Addendum No. 1

Project: Francis Marion University
Deferred Maintenance – McNair and Leatherman Roofs
4822 E Palmetto Street
Florence, SC 29506

WMBE Project Number: 2024-81

Questions and Answers

R-1.3

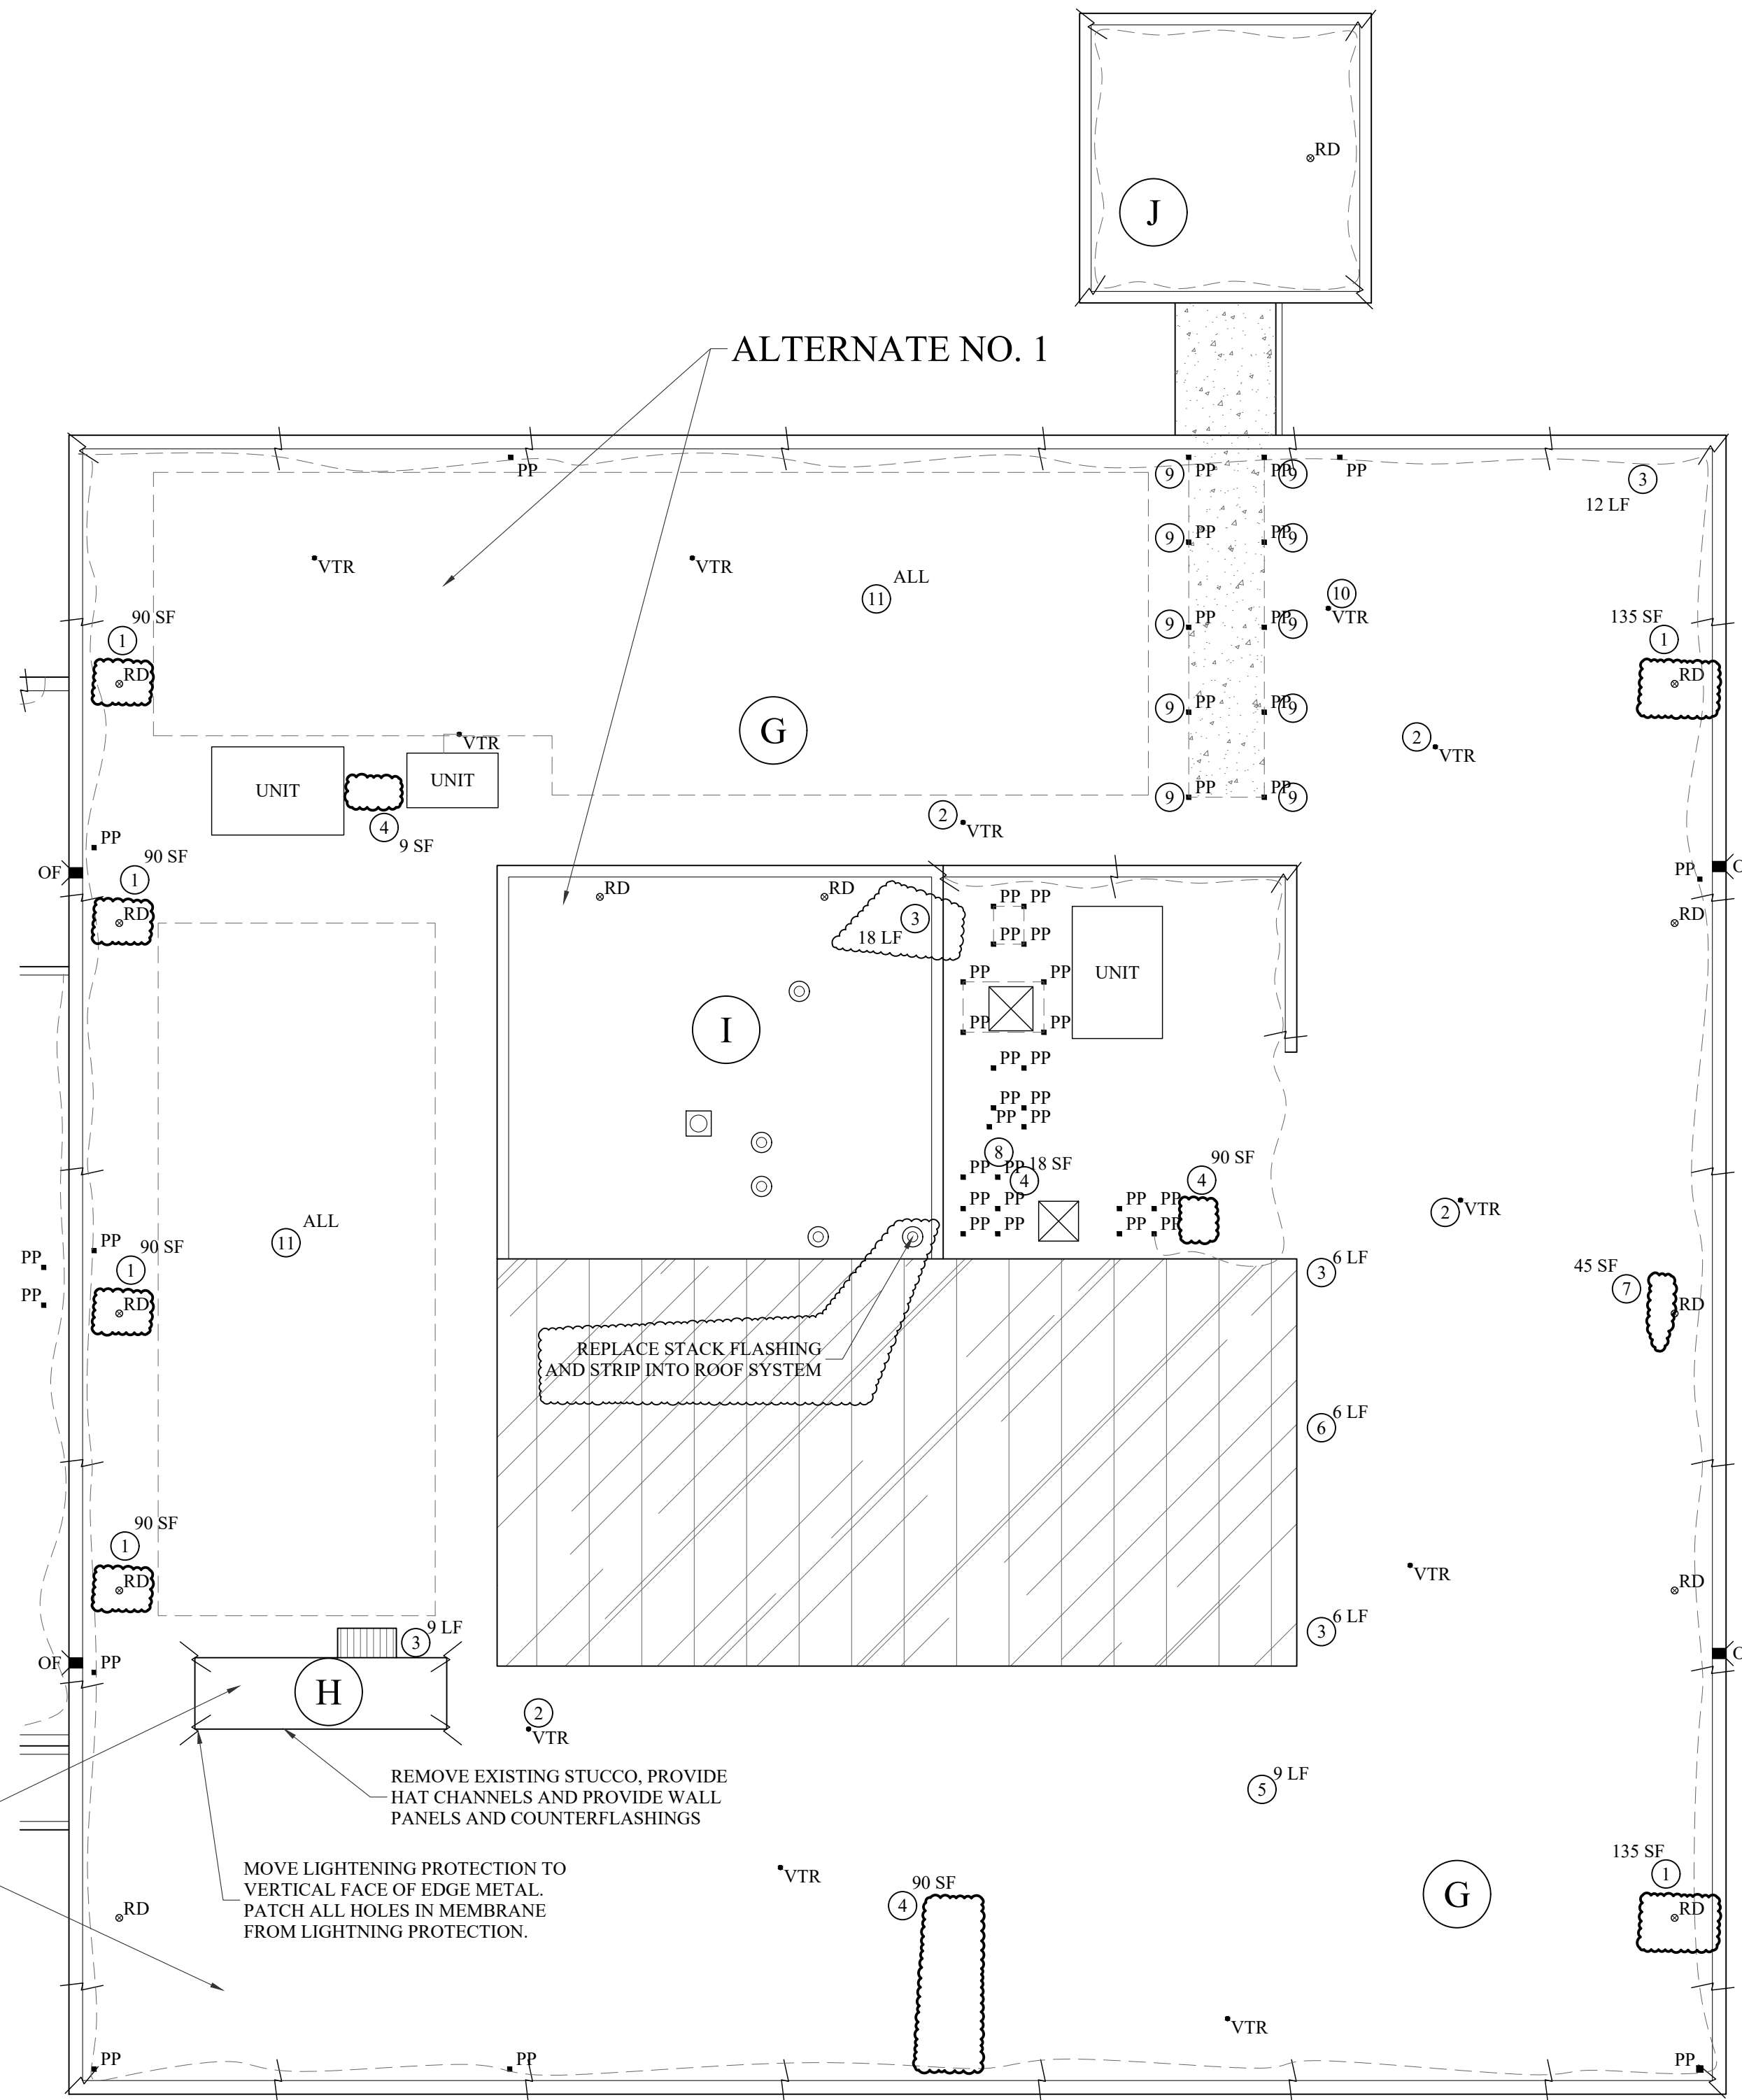
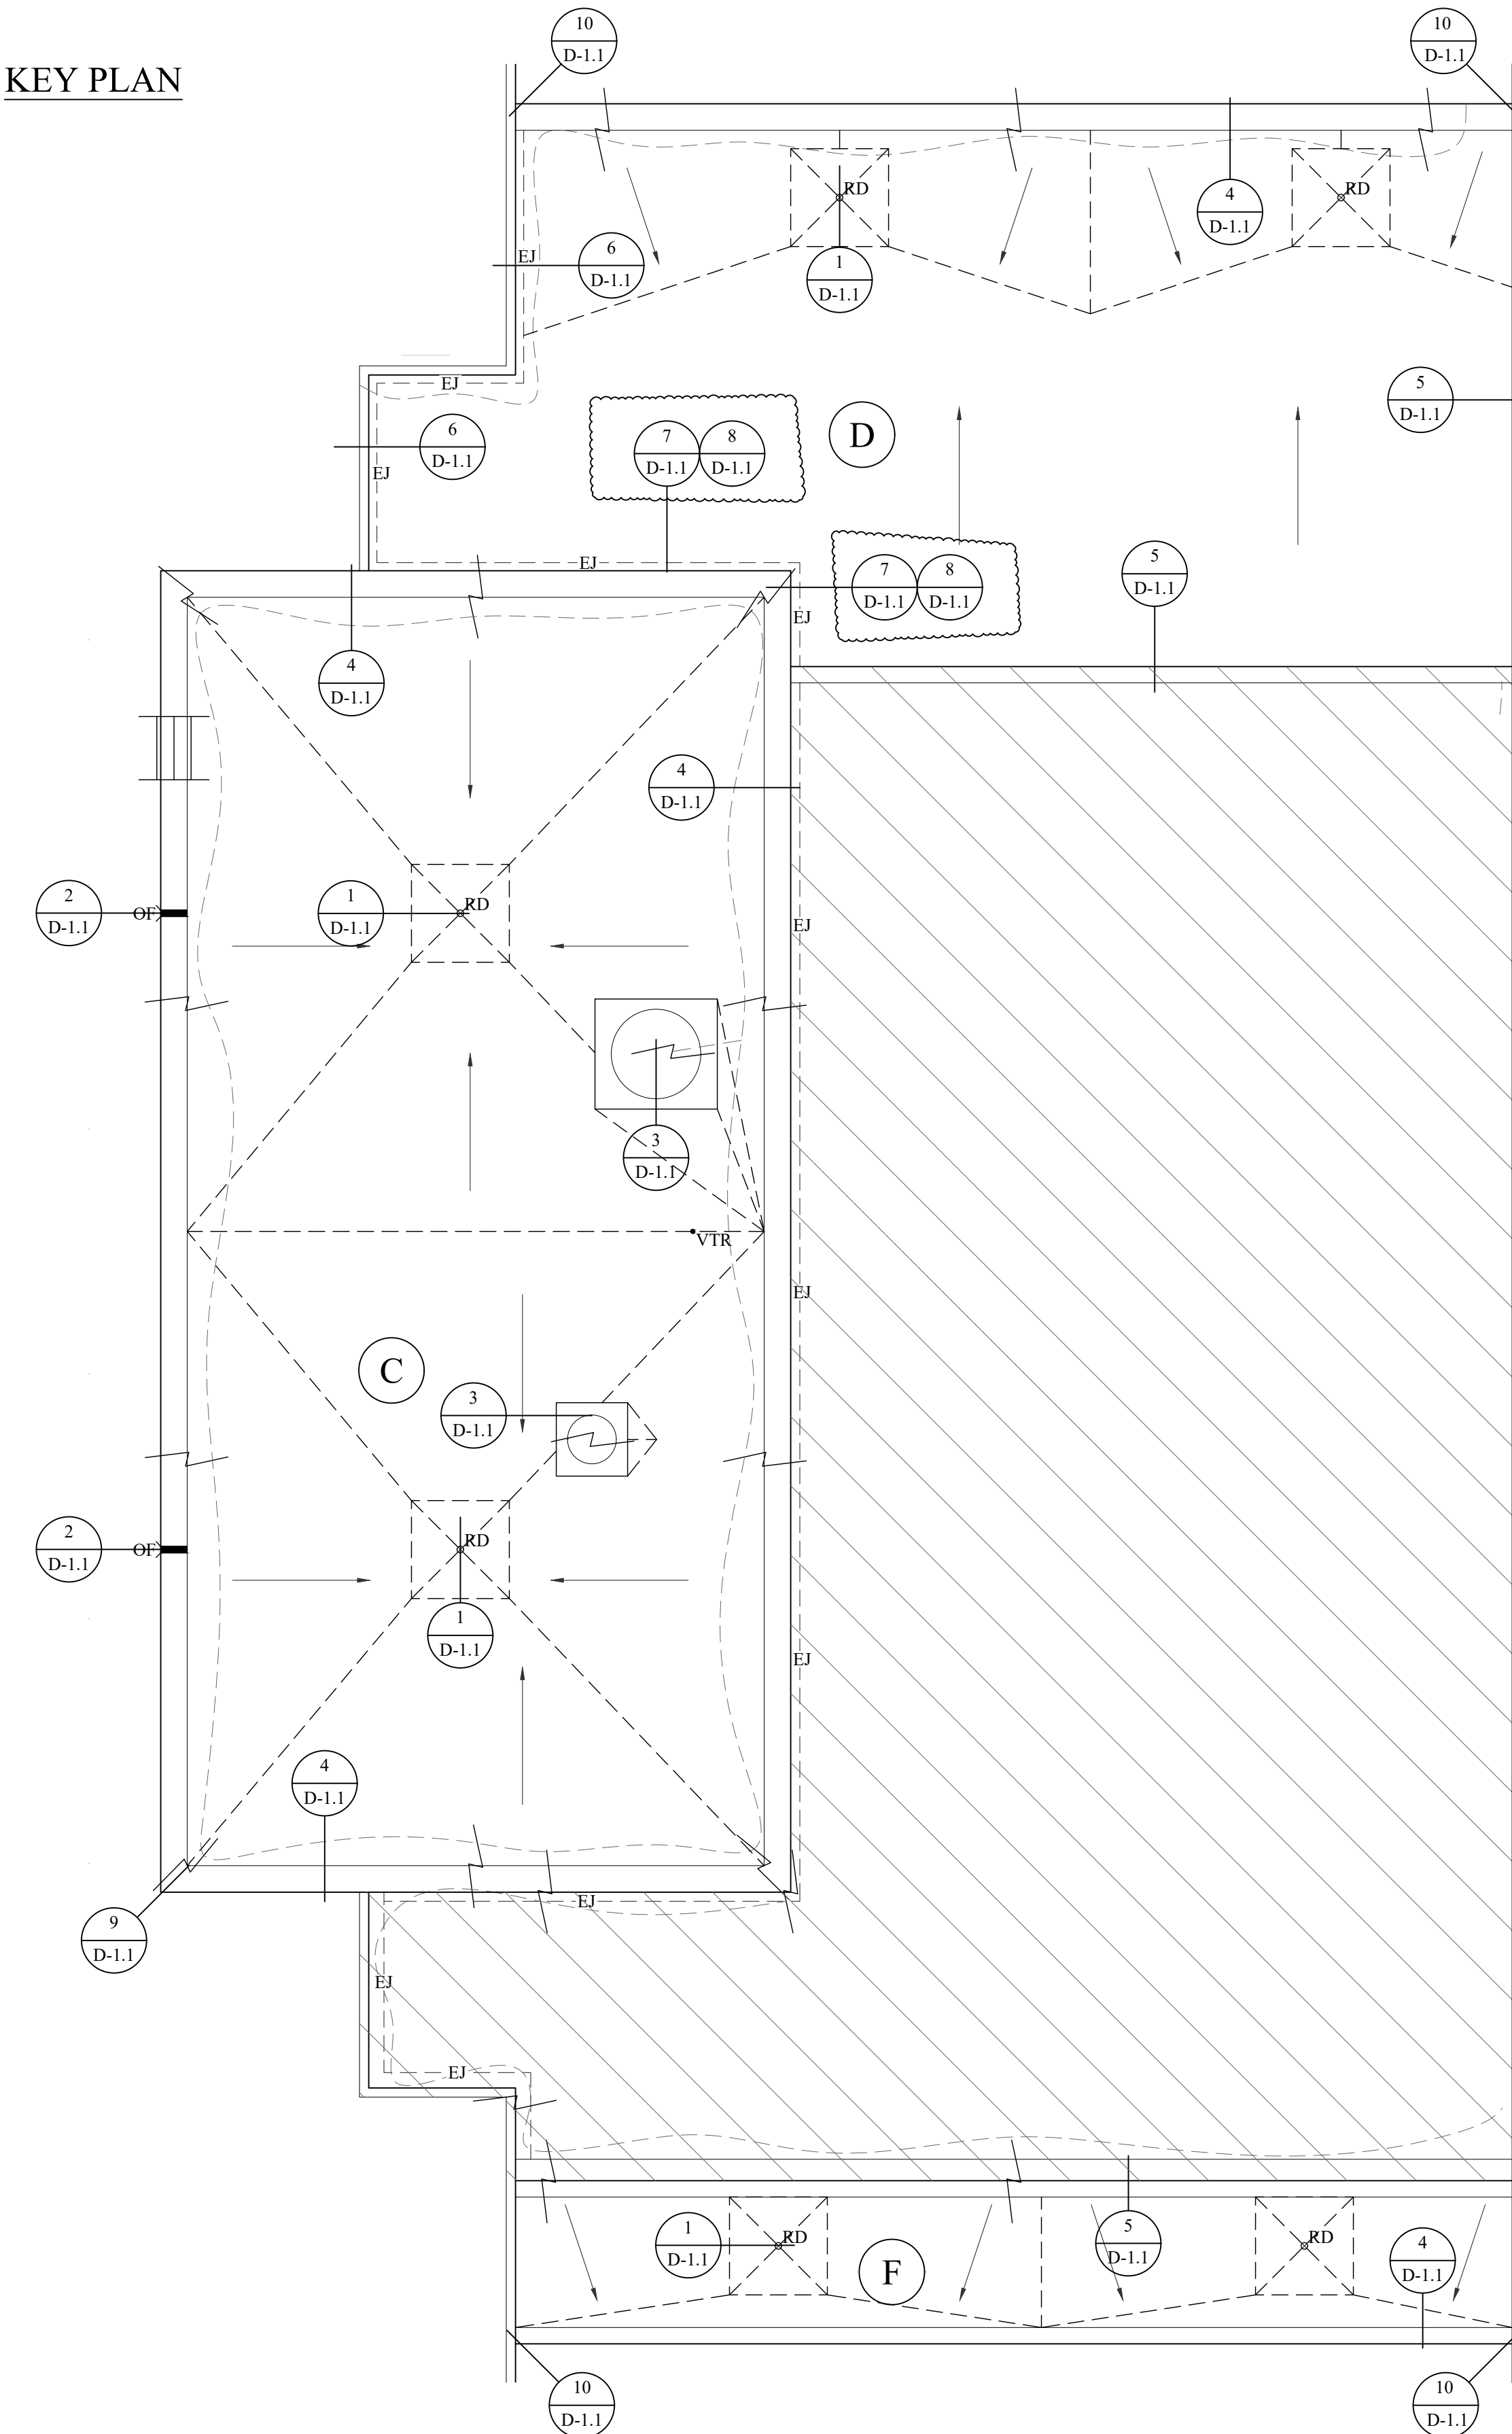
3. **Question:** Thru Wall Flashing replacement details have been included. Can you please clarify where these details/work is required?
A. **Answer:** See the updated New Roof Plans (Base Bid) R-1.3 for the locations. Locations are at the expansion joint to wall termination on Roof Area D.

8. **Question:** Drawing R-1.3 at Roof Area D refers to detail D-1.1-5 should this one be D-1.1-6 base flashing at curtain wall?
- A. **Answer:** Please see the revised R-1.3 with corrected detail cuts.

9. **Question:** Drawings R1.3 at Roof Area D refers to detail D-1.1-6 should this one be D-1.1-7 base flashing at expansion joint?
- A. **Answer:** Please see the revised R-1.3 with corrected detail cuts.

10. **Question:** Drawings R1.3 at Roof Area F refers to detail D-1.1-5 should be this one be D-1.1-6 base flashing at curtain wall?
- A. **Answer:** Please see the revised R-1.3 with corrected detail cuts.

- A. **Answer:** Yes, please see attached updated Bid Form.
13. **Question:** Also did not see detail D-1.1-8 thru wall flashing repair noted on any of the drawings, in what area will this detail be required if at all?

1. Changes to Bidding Requirements:
 - a. Replace Bid Form with Attached Bid Form.
2. Changes to Specifications:
 - a. Change Specification Section 024119, 1.2, 1, d FROM “Roof Area E – Approximately 3 Squares” TO “Roof Area F – Approximately 3 Squares”.
3. Changes to Drawings:
 - a. Replace R-1.3 with the attached.
 - b. Replace R-1.5 with the attached.
 - c. Replace R-1.6 with the attached.

- A. **Answer:** Please see the revised R-1.3 with corrected detail cuts.
